<u>ENGINE - HP TURBINE ROTOR AND STATOR ASSEMBLY - PROVIDE NEW STAGE 2 HIGH PRESSURE</u>

<u>TURBINE VANES - CATEGORY CODE 8 - MOD.ENG-72-0259</u>

Location of the Stage 2 High Pressure Turbine (HPT) Vane Assemblies Fig.1

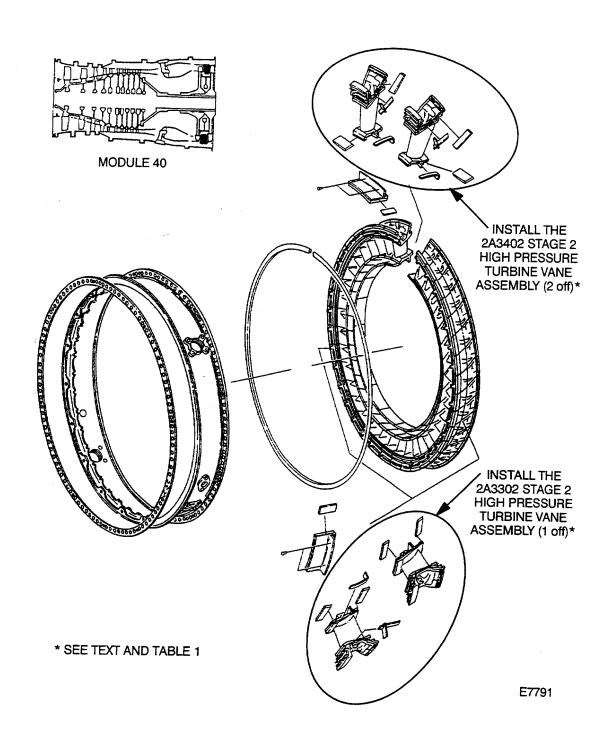
A. Replace the 2A3832 Stage 2 HPT Vane Assembly (2 off) with the 2A3402 Stage 2 HPT Vane Assembly when you assemble the new Stage 2 HPT Ring Segment and Vane Cluster Assembly by the procedure specified in Reference (4) or (5), Chapter/Section 72-45-24 Repair 18 (VRS 3391).

B. Replace the 2A3842 Stage 2 HPT Vane Assembly (1 off) with the 2A3302 Stage 2 HPT Vane Assembly when you assemble the new Stage 2 HPT Ring Segment and Vane Cluster Assembly by the procedure specified in Reference (4) or (5), Chapter/Section 72-45-24 Repair 18 (VRS 3391).

Family Tree- Stage 2 High Pressure Turbine Vane Assembly Ref. Catalog Sequence No. 72-45-24. Fig. 02 Items 130 and 350 Fig.2

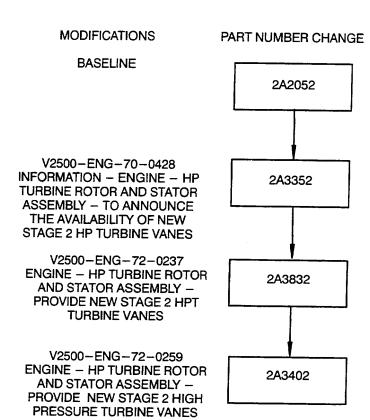
2A3402	2	Stage 2 HPT	2A3832	(S1)(A)(B)
(72-45-24)		Vane Assey.	(02-130)	
2A3302	1	Stage 2 HPT	2A3842	(S1)(A)(B)
(72-45-24)		Vane Assy.	(02-420)
